Reference: Planning application number HPK/2018/0048

**Description:** Proposal for "Change of use to residential. Detached new dwelling with onsite parking access off Chapel Brow"

## Impact on Privacy / Direct sunlight

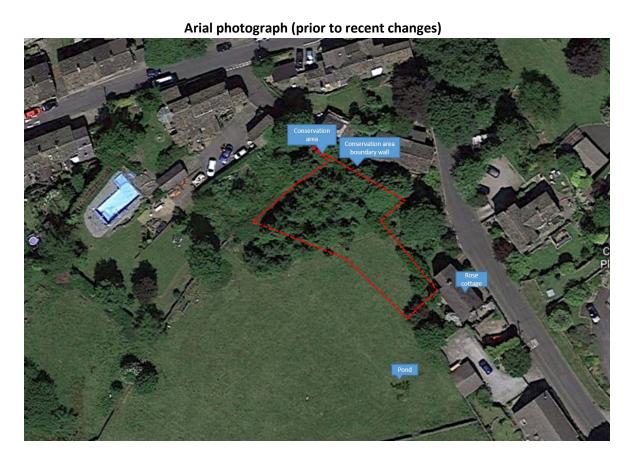
- The proposed garden layout will share a boundary with the full length of our front and rear gardens plus patio area. This will have a direct impact on our privacy.
- Also, there does not seem to be any restrictions specified on future fences, landscaping and garden buildings. This could have a further impact on our privacy, direct sunlight, and the conservation area outlook.
